CITY OF LAS VEGAS		DATE:
INTER-OFFICE MEMORANDUM		November 20, 2018
TO: Land Development Services Department of Building & Safety		FROM: Albert Sung, P.E. Flood Control Project Engineer Department of Public Works
SUBJECT:	Drainage Study for:	COPIES TO:
	Centennial Jensen 5	GCW Inc.
Cross Streets:	SWC of Centennial Parkway & Jensen Street	D.R. Horton
File Number:	F:\Depot\DSMemos\DS5056A.doc	Bart Anderson, P.E., DevCo
Parcel Number:	125-30-101-006	CCPW
Zoning Action:	TMP-XXXXX	
FEMA Flood Zone	YES	NO X
Proposed Storm Drain	YES	NO X

The Drainage Study for the subject project has been reviewed and:

CENTENNIAL JENSEN 5

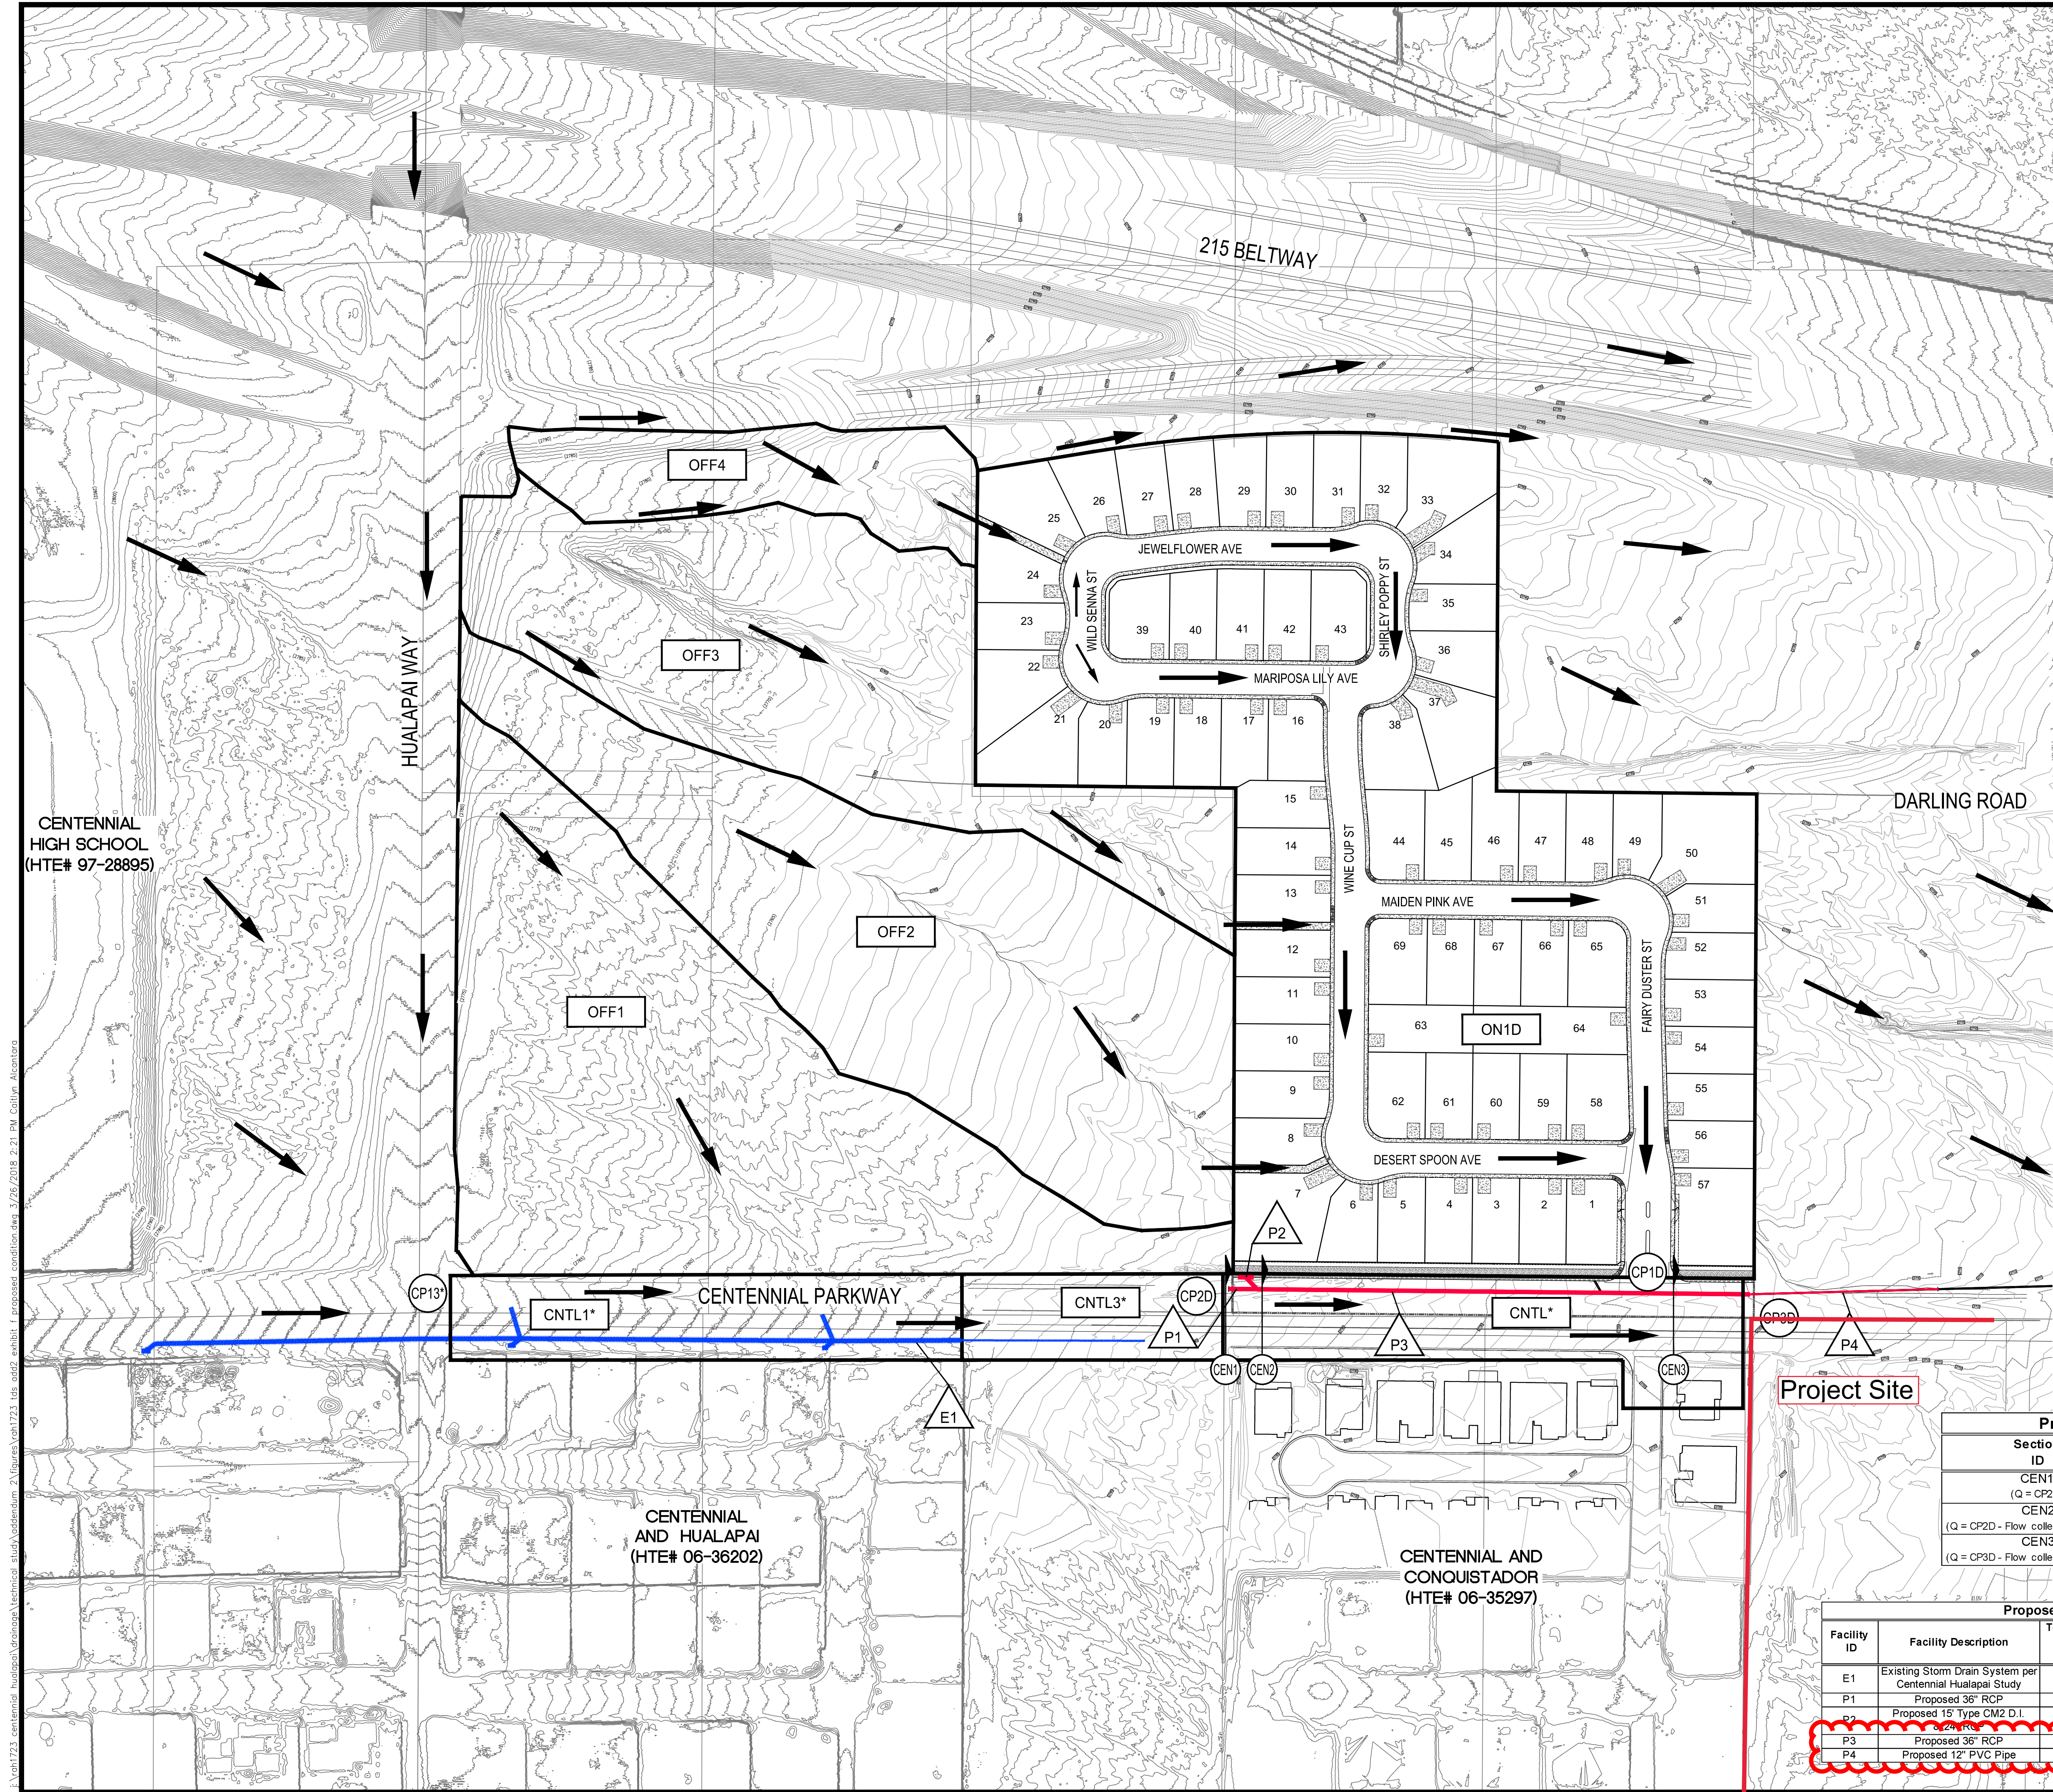
5. **Figure 5 (Existing Condition Drainage Map)** shows that the flows in *Centennial Parkway* (133/289cfs) split about half into *Jensen Street* (67/145cfs) through the unobstructed onsite property. However, in **Figure 6 (Proposed Condition Drainage Map)**, it still shows that about half of the flows in *Centennial Parkway* split into *Jensen Street*.

Because of the proposed development with walls along *Centennial Parkway*, it is not probable that half of the flows will split into *Jensen* anymore. Provide split flow calculation in the next submittal to find out the exact flow into *Jensen Street*. The post-development condition should improve the impact at *Concentration Point CP2*.

6. **Figure 6:** The basin area shown for OFF1 is 8.47 acres, but per the provided *Standard Form 4* and Proposed HEC-1 it should be 3.08 acres.
7. **Figure 6:** The slope shown for *Hydraulic Section 5* is 0.29%, but the flow master reports show a slope of 1.45%. Review and revise the slope and all the subsequent calculation results accordingly.

Address and resolve in the next submittal.

GRADING PLAN 2

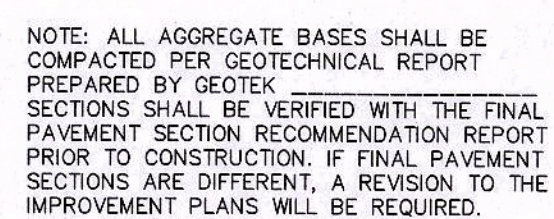
8. **Sheet G1:** Cross Sections A/D1, B/D1, E/D1, and M/D1 do not match the detail sections shown on Sheet D1.
9. **Sheet G2:** Cross section E/D1 does not match the detail section shown on Sheet D1.

10. **Sheet G2:** Provide finished floor elevation of existing houses to the south and east of the project.
11. **Sheet D1:** There are two "E" cross sections, rename one to remove confusion.
